## SERVICE BULLETIN 01/2017

**Subject:** Increase security of ballistic rescue system

**Airplanes Affected (s/n):** JA-400:

Old solution:

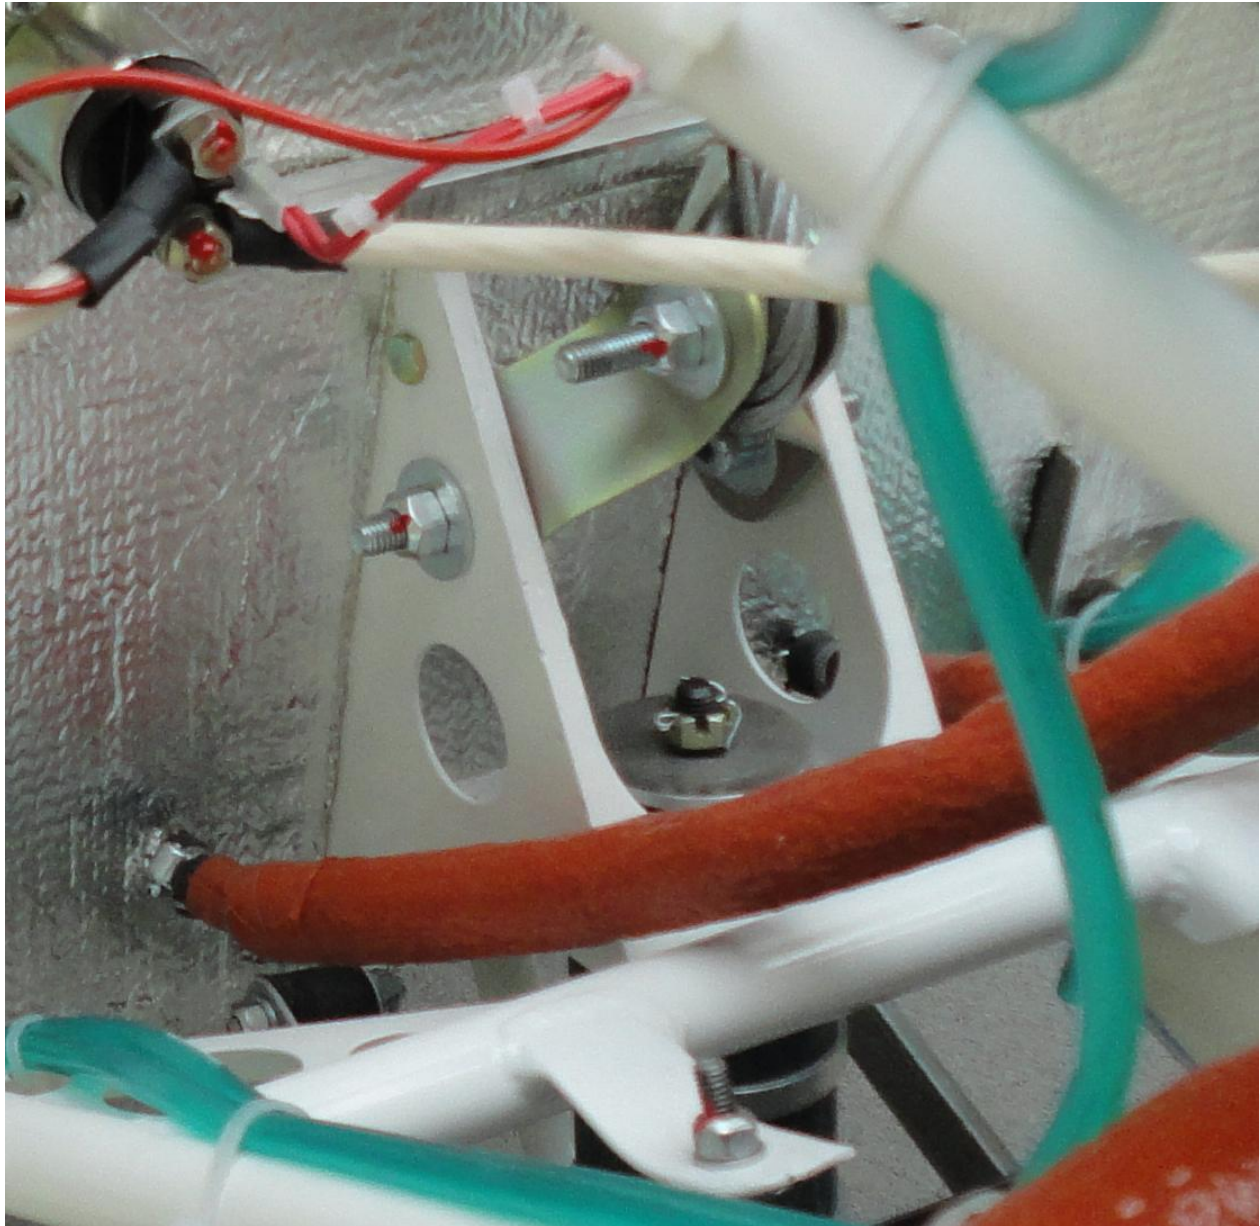
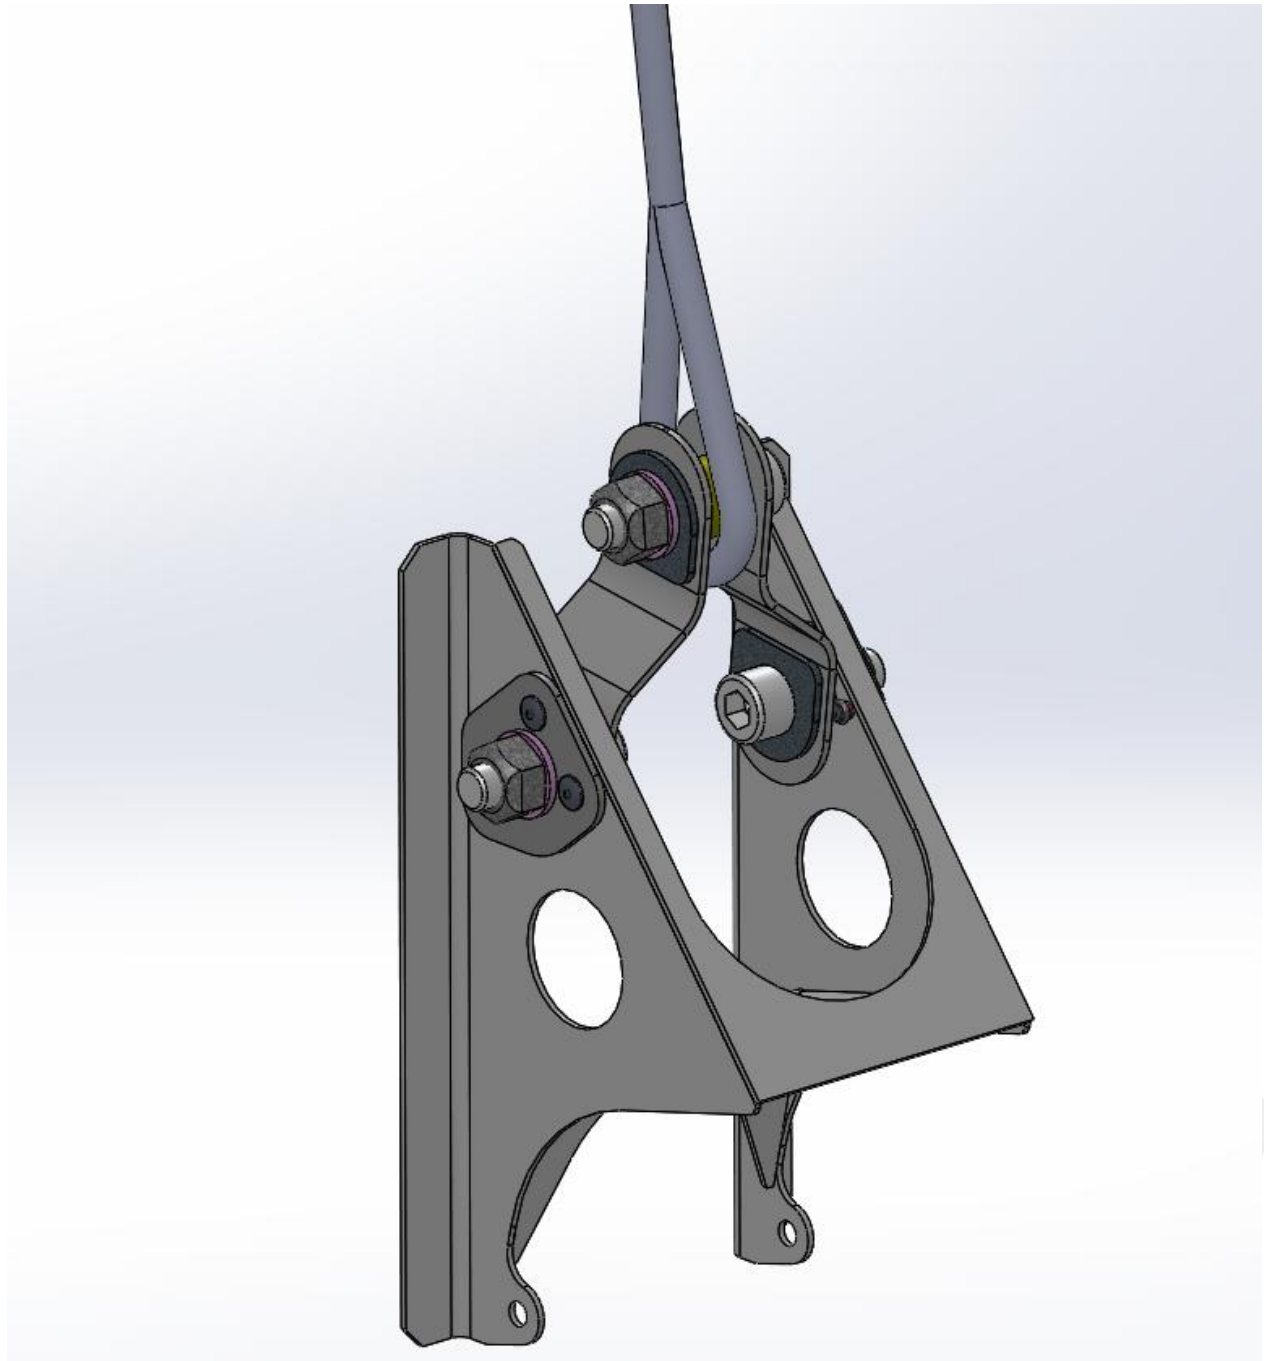
**Description:** Exchange parts in hinge rescue system.

**Action:** Please, you must to change parts in hinge rescue system. Please refer to the enclosed drawing documentation. Tightening torque is 25 Nm for nuts. It is necessary to insure nuts by Loctite Threadlocker Blue 242 or similar.

- 421\_216      4 ks
- 421\_215      2 ks
- 421\_208      2 ks
- 421\_009      2 ks
- 901\_044      1 ks
- 901\_155      2 ks
- 905\_005      3 ks
- 904\_008      3 ks
- 911\_008      6 ks
